SERVICE BULLETIN

M-839

BATTERY CABLE ROUTING — 1982 XL MODELS

Figure 1. Connection to Starter

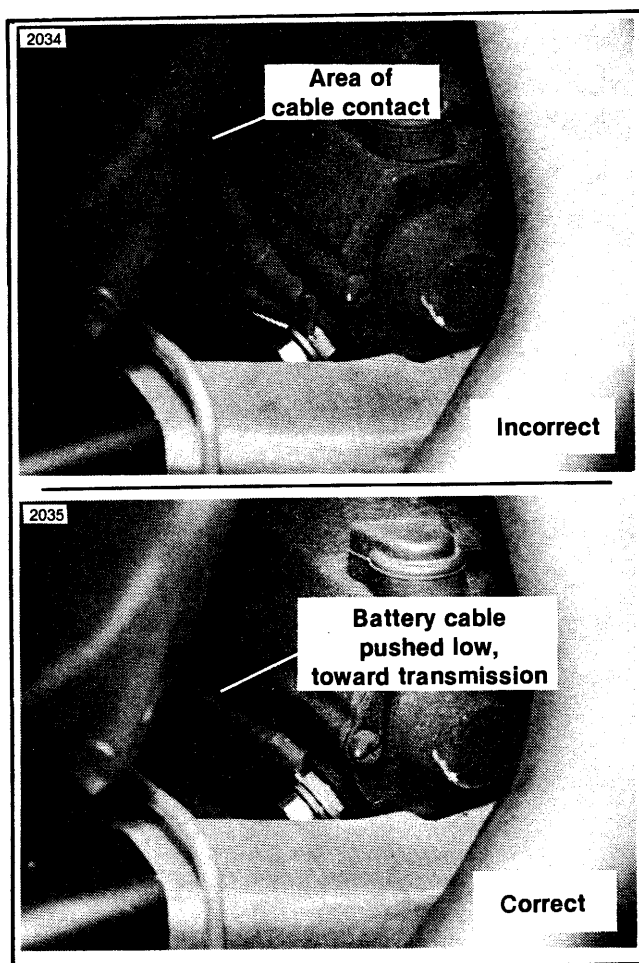
The positive battery cable on some 1982 vehicles, prior to VIN 1HD1CAH15CY111159, may contact the leading edge of the oil tank. This surface could cut the insulation, causing a short circuit.

See Figure 1 and 2. Inspect all vehicles during predelivery and setup. Reroute cable, if required, per illustrations below.
